Informal document No. 12  
(51<sup>st</sup> GRE, 15-19 September 2003  
agenda item 4.1.)

PROPOSAL FOR A GLOBAL TECHNICAL REGULATION:

UNIFORM PROVISIONS CONCERNING VEHICLES  
WITH REGARD TO THE INSTALLATION OF LIGHTING AND LIGHT-SIGNALLING  
DEVICES

Transmitted by the Expert from Canada.

FIGURE 2. (see paragraphs 5.5. and 5.18.)

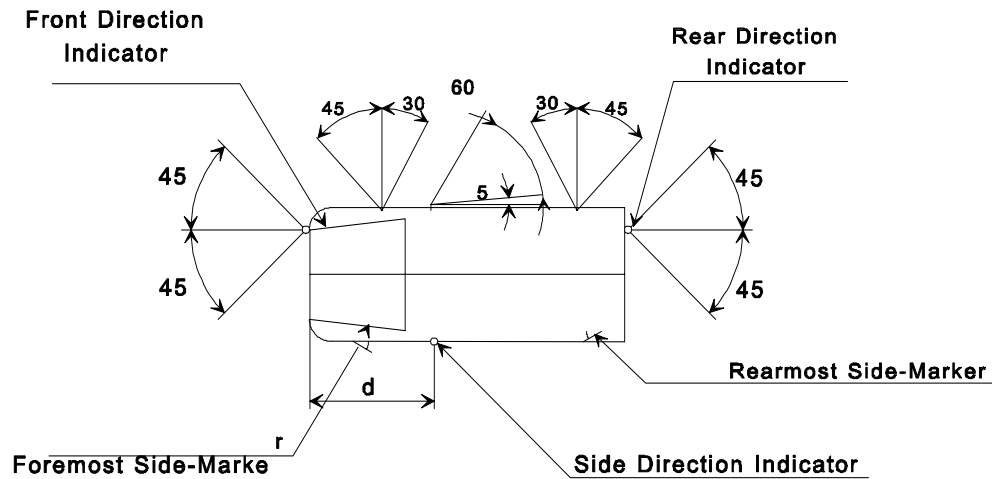
Installation of direction indicators and side marker lamps  
/ the above figure will be corrected and 80 deg angle option for direction indicators will be added; **verify angles for all devices.**/
